Access Compliance Report

Public Rights-of-Way

Intersection ID: 31349	Main Street: OAK_PASTURE_LN	Cross Street: SAGUARO_CT	Location:	N
ADA ID: 51D8BEB6F0B8	Ramp Type: PerpDiag	Initial Pass/Fail: Fail	Overall Compliance: No	Severity Score: 13.75
Codes/Mitigation Info/Possible Solution		Field Measurements/Component Compliance

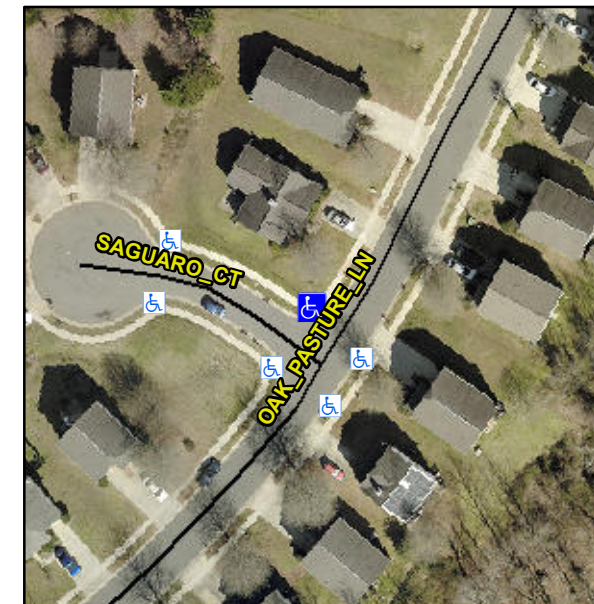
Not Found, R304.2.2, R304.5.3

Compliance	Description	Data	Compliance	Description	Data
N/A	Ramp Length (in)	48.0	No	Ramp Slope (%)	8.9
Yes	Ramp Width (in)	51.0	No	Ramp XSlope (%)	4.9
N/A	Flare Type LT	N/A	N/A	Flare Type RT	N/A
N/A	Flare Slope LT (%)	N/A	N/A	Flare Slope RT (%)	N/A
N/A	Flare Traversable LT?	N/A	N/A	Flare Traversable RT?	N/A
N/A	Landing Length (in)	N/A	N/A	DWS Provided?	N/A
N/A	Landing Width (in)	N/A	N/A	DWS Contrast?	N/A
N/A	Landing Slope (%)	N/A	N/A	DWS Length (in)	N/A
N/A	Landing X Slope (%)	N/A	N/A	DWS Full Width?	N/A
N/A	Landing Curb? (Y/N)	N/A	N/A	DWS Offset (in)	N/A
N/A	Shared Landing?	N/A			
N/A	Gutter Ponding?	N/A	N/A	Gutter Slope (%)	N/A
N/A	Gutter Lip Ht (in)	1.0	N/A	Gutter X Slope (%)	N/A
N/A	Painted X Walk1?	No	N/A	Painted X Walk2?	No
	X Walk 1 Direction	To SW		X Walk 2 Direction	To SE
N/A	X Walk 1 Width (in)	N/A	N/A	X Walk 2 Width (in)	N/A
	X Walk 1 Slope (%)	0.1		X Walk 2 Slope (%)	0.6
	X Walk 1 X Slope (%)	1.6		X Walk 2 X Slope (%)	3.6

Remove & Replace Curb Ramp With Two New Directional Ramps or Equivalent.
